WEBSTER UNIVERSITY ISB
PROJECT NAME

PROJECT: 15051-Webster University Interdisciplinary Science Building

RE: Alternating Tread Stair to Roof Shop Drawings

EF-16186-A
Alternating Tread Stair

68
192.000 inch ~~56~~ Degree Carbon Steel, Gray Primer with Optional Straight Handrail

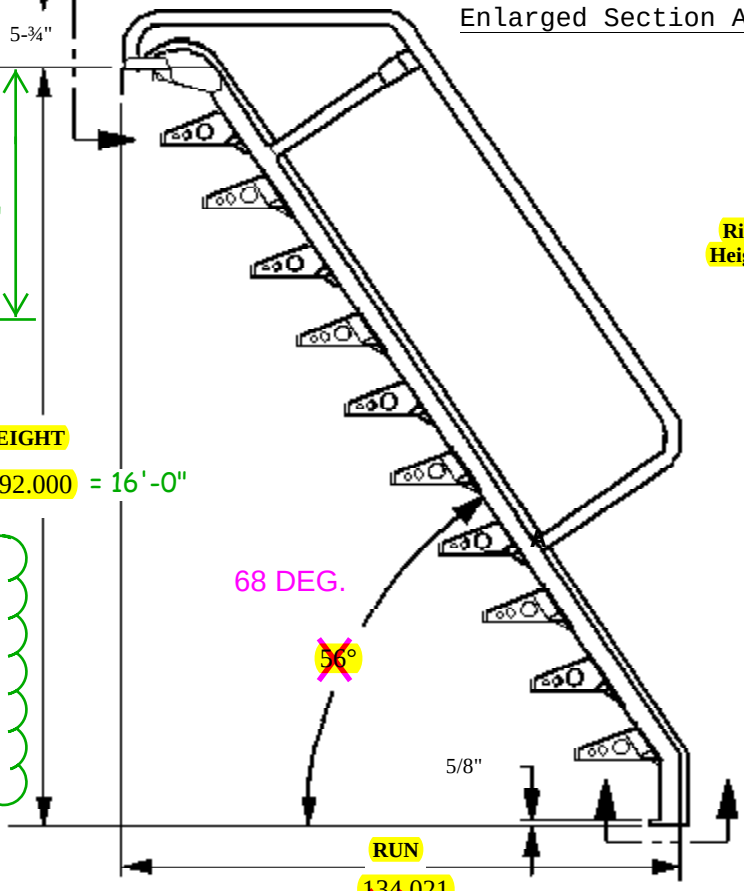
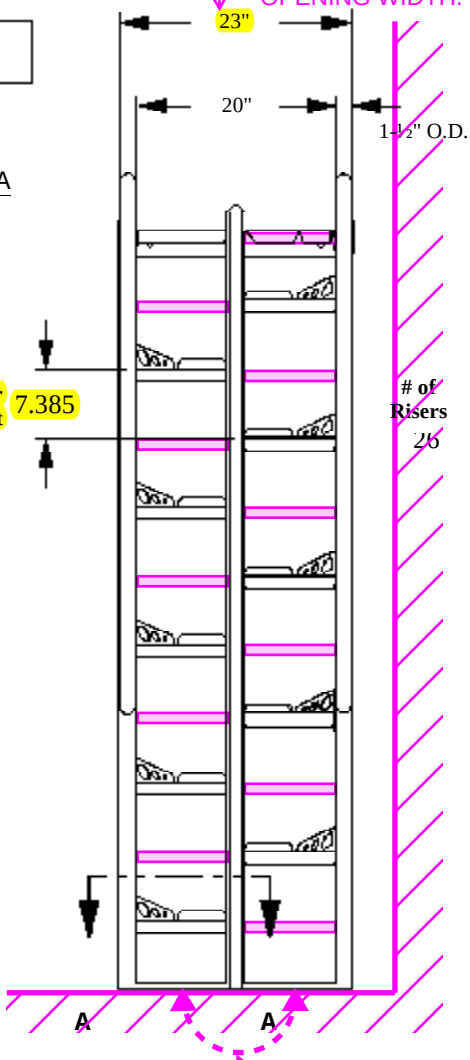
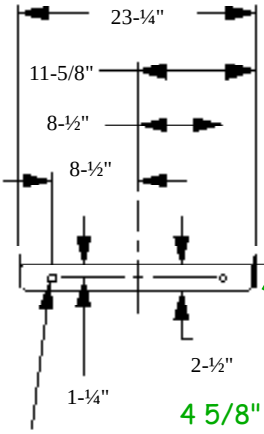
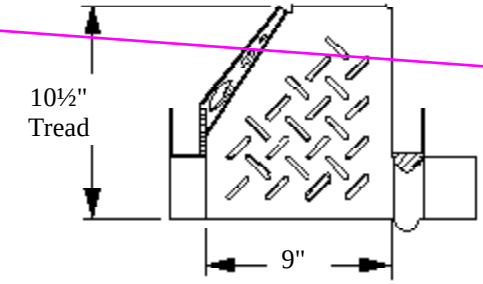
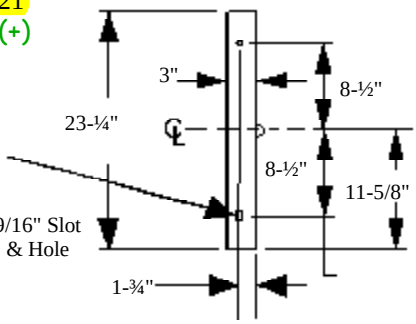
APPROVER,
PLEASE VERIFY HIGHLIGHTED ITEMS - BOTH PAGES.

- ~~We chose the 56 degree ladder based on LaPeyer's recommendation of `preferred usage'.~~ The other option is their 68 degree (steeper) ladder.
- As there are no dimensions for the Roof Access Room S494A on 4/A0502, we do not know if there is sufficient horizontal space for this ladder.
  - ~~The 56 degree ladder requires roughly 11'-2" horizontally, plus room to access the ladder.~~
  - The 68 degree ladder requires roughly 7'-0" horizontally, plus room to access the ladder.
  - 055000-2.12 do not indicate the pitch of the ladder.
- We show the ladder as 16'-0" tall (to the top `rung'). 5/A0471 shows something else, and LaPeyre indicates the top `rung' should be level with the roof.
  - We ask that the approver advise the height of the ladder to be furnished.

GC TO COORDINATE STAIR WIDTH REQUIREMENTS WITH ROOF HATCH OPENING WIDTH.

IF TOP TREAD IS TO BE LEVEL WITH ROOF THEN LADDER WILL NEED TO BE 195" (16'-3")
~ SEE 5/A0471

MIRROR STAIR SO THAT THE FIRST TREAD IS CLOSEST TO ADJACENT SIDE WALL

PROVIDE 68 DEGREE LADDER TO FIT WITHIN THE ROOM.

TOP TREAD TO BE LEVEL WITH ROOF. GC TO COORDINATE WITH ROOF HATCH.

PROVIDE ZINC-RICH PRIMER PER SPEC.
